# **NPP WYLFA NEWYDD (UK)**

## Expert Statement on the Environmental Impact Assessment

By Order of the Federal Ministry for Sustainability and Tourism  
Directorate I/6 General Coordination of Nuclear Affairs  
GZ BMLFUW.1.1.2/0007-I/6/2017

Figure 2:  
Caesium-137  
depositions after a  
severe accident at the  
Wylfa NPP site

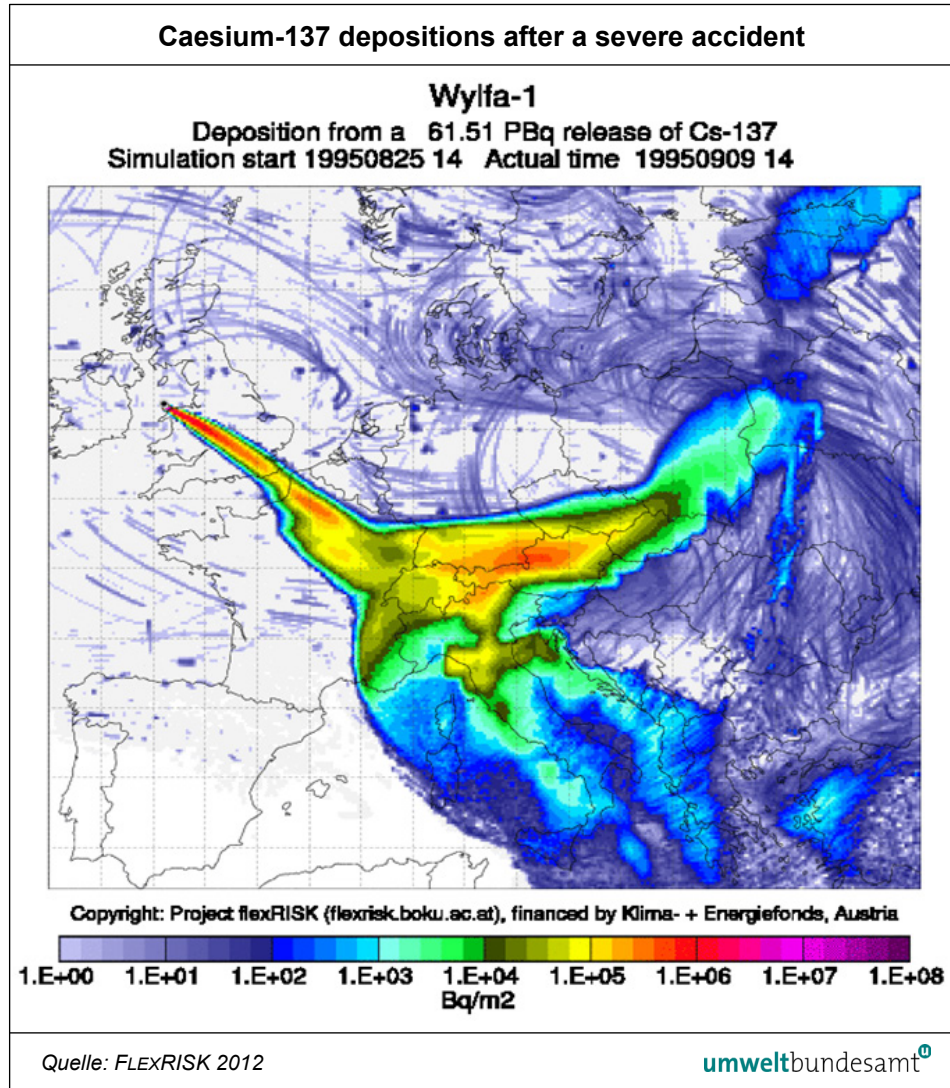
A considerable contamination of the Austrian territory would result from a potential Caesium-137 release of 61.5 PBq (6.15E+16 Bq) at the Wylfa NPP site under conditions comparable to those on 25 August 1995. Almost all regions in Austria would receive depositions of more than 1,000 Bq/m<sup>2</sup> (1E+03 Bq/m<sup>2</sup>). In large areas the values are above 1E+05 Bq/m<sup>2</sup>, even up to 6E+05 Bq/m<sup>2</sup>.

Figure 2 shows that Austria and many other countries (including France, Germany and Switzerland) could be affected by a severe accident occurring at the Wylfa NPP site.
